# EPIC<sup>®</sup> Newsletter

Edition June 2008

## EPIC<sup>®</sup> H-B housings with new bolts

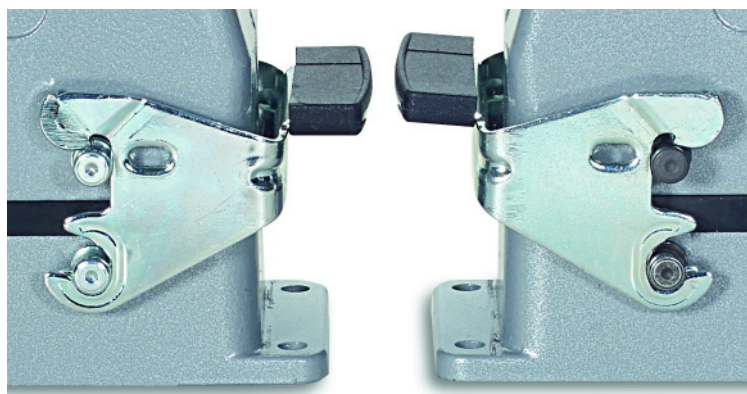
The housings of the H-B series will get new bolts with another surface. The new bolts are applied for hoods and cable coupler hood, as well as panel mount bases and surface mount bases with double levers size H-B 6, 10, 16, 24, H-A 32 und H-A 48. The product H-B 32 is changed in cable coupler hood, panel mount bases and surface mount bases. This change is going to affect several hundred products.

- New improved corrosion protection against salt mist
- Much better sliding characteristic for the movement of the lever
- Anthracite colored design of the bolts

The part numbers of the affected housings stay unchanged. This optimization will flow continuously into the production. Due to the large variety of products and different range of stocks in some cases its possible to have mixed deliveries to the customers. The production of the new bolts has already started.
